Title - Sujet Cladding Replacement, SABS	
Solicitation No. - N° de l'invitation EC016-171374/A	Amendment No. - N° modif. 002
Client Reference No. - N° de référence du client R.082678.001	Date 2016-09-20
GETS Reference No. - N° de référence de SEAG PW-\$PWB-013-3954	
File No. - N° de dossier PWB-6-39088 (013)	CCC No./N° CCC - FMS No./N° VME
Solicitation Closes - L'invitation prend fin at - à 02:00 PM on - le 2016-09-27	Time Zone Fuseau horaire Atlantic Daylight Saving Time ADT
F.O.B. - F.A.B. Plant-Usine: <input type="checkbox"/> Destination: <input checked="" type="checkbox"/> Other-Autre: <input type="checkbox"/>	
Address Enquiries to: - Adresser toutes questions à: Johnston, Edward PWB	Buyer Id - Id de l'acheteur pwb013
Telephone No. - N° de téléphone (506) 636-4416 ()	FAX No. - N° de FAX (506) 636-4376
Destination - of Goods, Services, and Construction: Destination - des biens, services et construction:

Modification numéro 2

Public Works and Government Services Canada Travaux publics et Services gouvernementaux Canada		Drawing title BUILDING ELEVATION KEY		Title du dessin designed RJM drawn HGA approved		conçu date SEPT. 2016 dessiné date SEPT. 2016 approuvé date	
project ST.

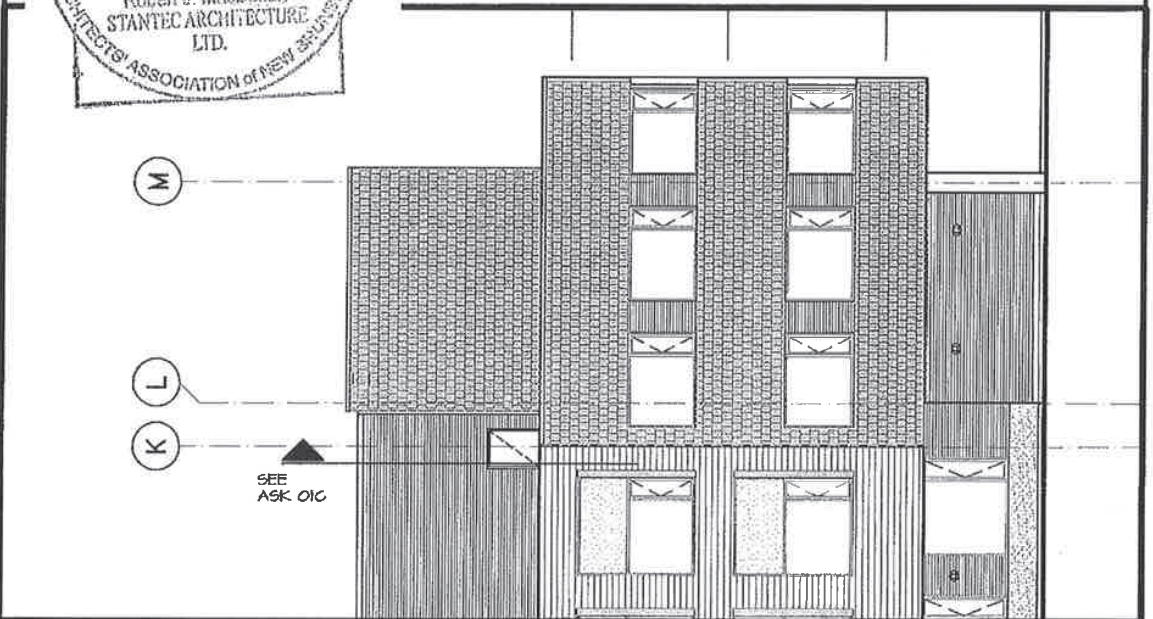
Item 1 Drawing Ask 01A, Ask 01B and Ask 01C (attached), remove existing cement board cladding and supply and install metal cladding in areas indicated on sketches.

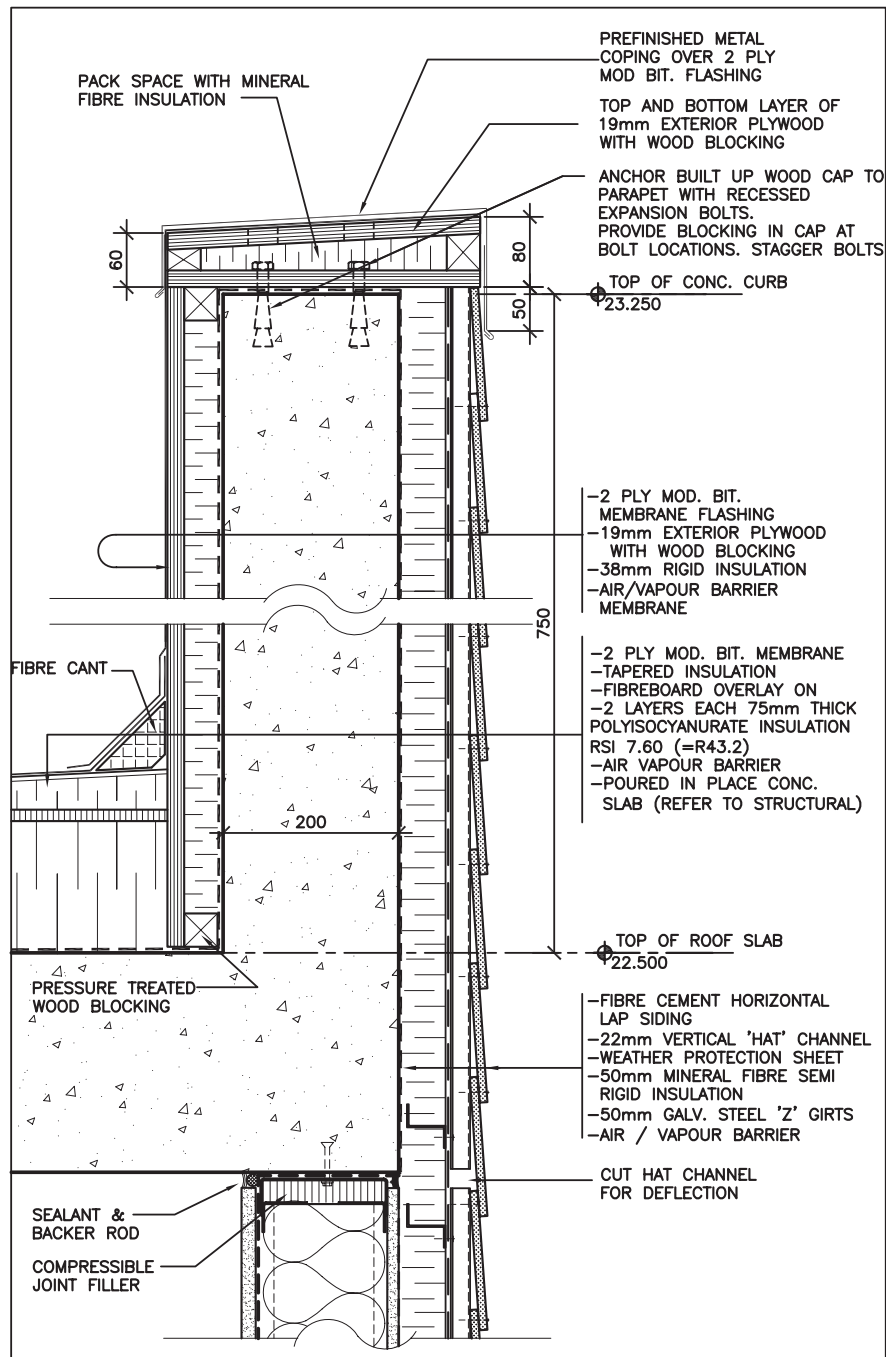
Q4: Is it possible to have a detail for the roof parapet?

A4: See attached ASK 02 (for information purposes only).
